Ref. LCR 77-12

REQUEST FOR AMENDMENT  
FACILITY OPERATING LICENSE DPR-70  
UNIT NO. 1  
SALEM GENERATING STATION  
DOCKET NO. 50-272

ALEM NUCLEAR GENERATING STATION  
 ENVIRONMENTAL TECHNICAL SPECIFICATIONS  
 SUMMARY OF PROPOSED CHANGES  
 (Second Set)

FIG. 5.2-1

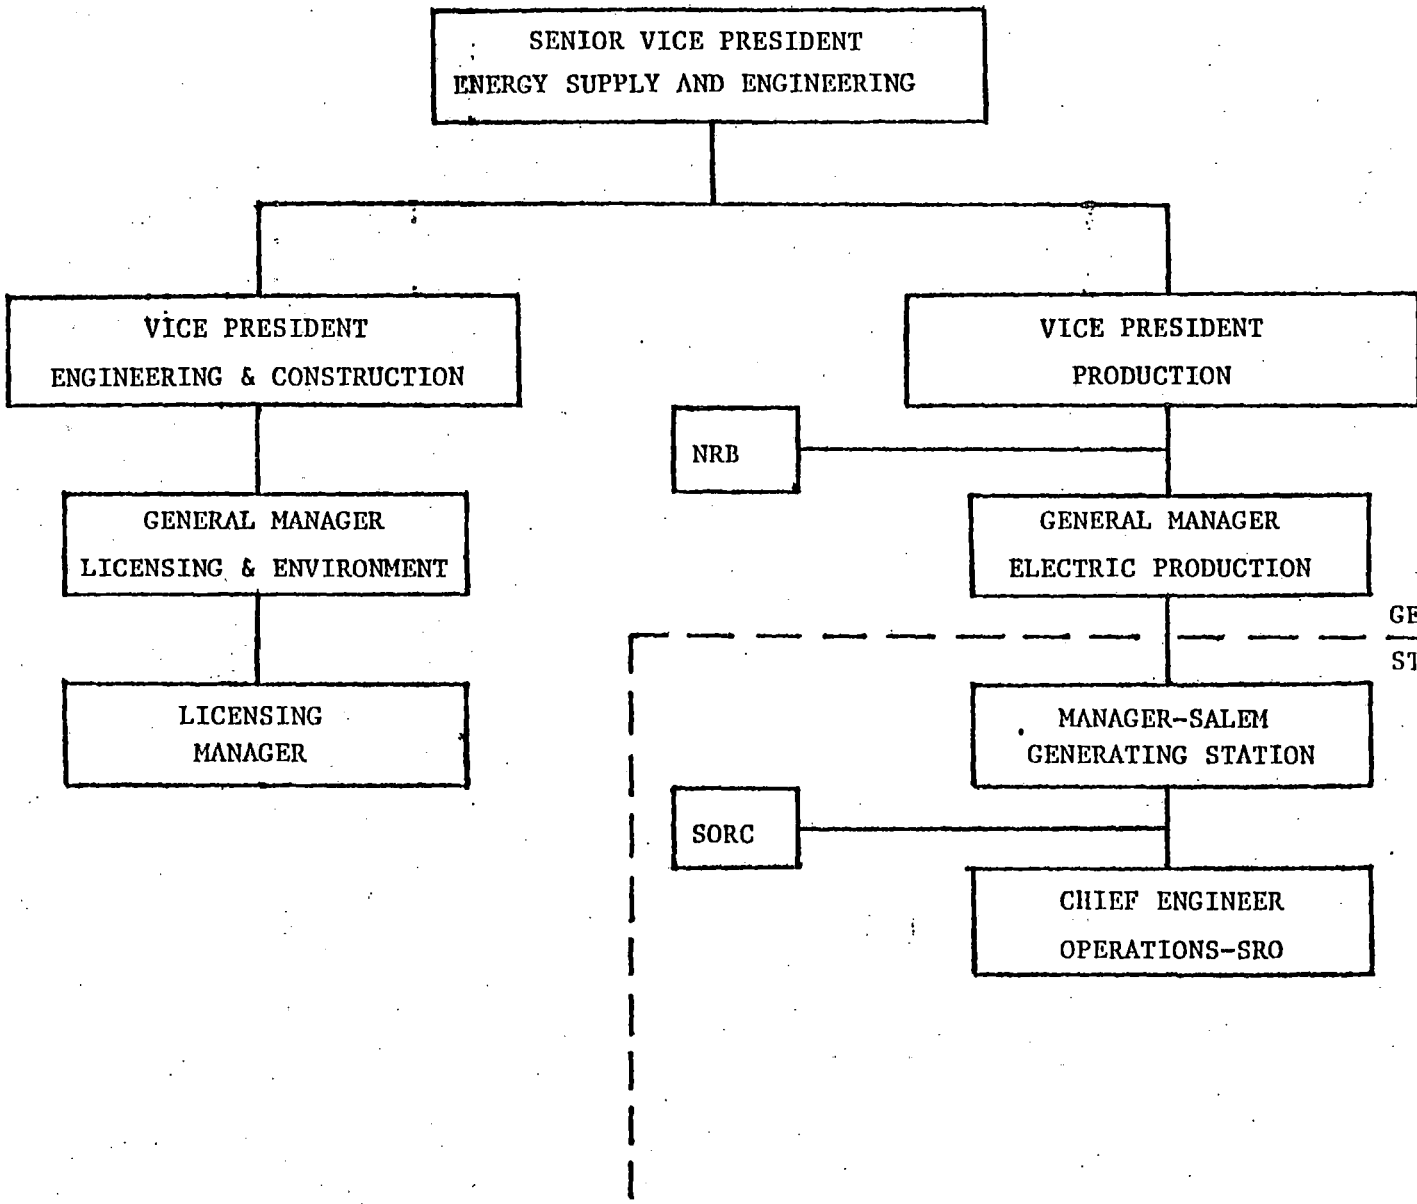
<u>SECTION</u>	<u>TITLE</u>	<u>REMARKS/JUSTIFICATION</u>
4.2.3 (pages 4.2-3 and 4.2-31)	<u>TEMPERATURE AND CHEMICAL AVOIDANCE STUDIES</u>	Clarification of analysis procedures.
5.1.1 (page 5.1-1)	<u>RESPONSIBILITY</u>	Changes to PSE&G internal organization.
5.2.1 (page 5.2-1)	<u>ORGANIZATION</u>	Changes to PSE&G internal organization.
Figs. 5.2-1 thru 5.2-2 (pages 5.2-2 thru 5.2-3)	<u>ORGANIZATION CHARTS</u>	Substitution of updated charts, including consolida- tion of two figures into one.

5.2.1 Figure 5.2-1 identifies the corporate relationship between the Licensing and Environmental Department and the station Manager and also shows the organization of the Licensing and Environment Department. Figure 6.2.2 of the Radiological Safety Technical Specifications identifies the Production Department Station Organization.

5.2.2 The Nuclear Review Board (NRB) and Station Operations Review Committee (SORC) are shown in Figure 5.2-1. They are advisory groups to the Vice President - Production and the station Manager respectively.
